SUBJECT: INDIVIDUAL PLANT EXAMINATION OF EXTERNAL EVENTS (TAC NO. M83607)

REQUEST FOR ADDITIONAL INFORMATION

CLINTON POWER STATION

Docket No. 50-461

Figure A.1 Sensitivity of the hot gas layer temperature predictions to the assumed heat loss factor

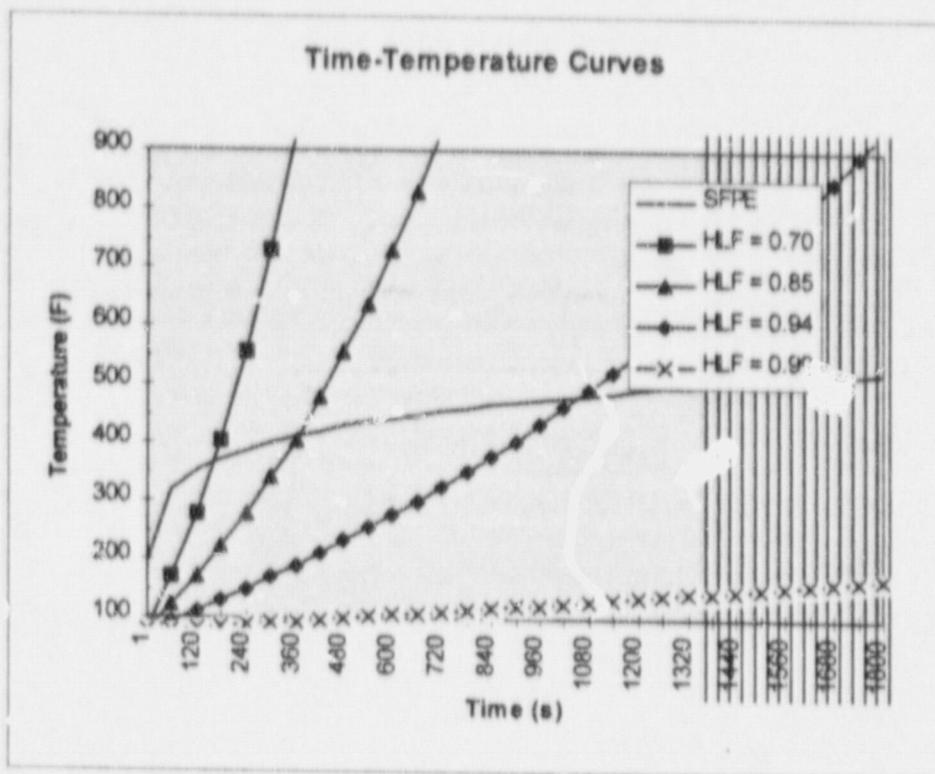
- 1) The heat loss factor is defined as the fraction of energy released by a fire that is transferred to the enclosure boundaries. This is a key parameter in the prediction of component damage, as it determines the amount of heat available to the hot gas layer. In Fire-Induced Vulnerability Evaluation (FIVE), the heat loss factor is modeled as being inversely related to the amount of heat required to cause a given temperature rise. Thus, for example, a larger heat loss factor means that a larger amount of heat (due to a more severe fire, a longer burning time, or both) is needed to cause a given temperature rise. It can be seen that if the value assumed for the heat loss factor is unrealistically high, fire scenarios can be improperly screened out. Figure A.1 provides a representative example of how hot gas layer temperature predictions can change assuming different heat loss factors. Note that: 1) the curves are computed for a 1000 kW fire in a 10m x 5m x 4m compartment with a forced ventilation rate of 1130 cfm; 2) the FIVE-recommended damage temperature for qualified cable is 700°F for qualified cable and 450°F for unqualified cable; and 3) the curve (SFPE) in the figure is generated from a correlation provided in the Society for Fire Protection Engineers Handbook [1].

Based on evidence provided by a 1982 paper by Cooper et al. [2], the *EPR Fire PRA Implementation Guide* recommends a heat loss factor of 0.94 for fires with durations greater than five minutes and 0.85 for "exposure fires away from a wall and quickly developing hot gas layers." However, as a general statement, this appears to be a misinterpretation of the results. Reference [2], which documents the results of multi-compartment fire experiments, states that the higher heat loss factors are associated with the movement of the hot gas layer from the burning compartment to adjacent, cooler compartments. Earlier in the experiments, where the hot gas layer is limited to the burning compartment, Reference [2] reports much lower heat loss factors (on the order of 0.51 to 0.74). These lower heat loss factors are more appropriate when analyzing a single compartment fire. In summary, (a) hot gas layer predictions are very sensitive to the assumed value of the heat loss factor; and (b) large heat loss factors cannot be justified for single-room scenarios based on the information referenced in the *EPR Fire PRA Implementation Guide*.

For each scenario where the hot gas layer temperature was calculated, please specify the heat loss factor value used in the analysis. In light of the preceding discussion, please either: a) justify the value used and discuss its effect on the identification of fire vulnerabilities, or b) repeat the analysis using a more justifiable value and provide the resulting change in scenario contribution to core damage frequency.
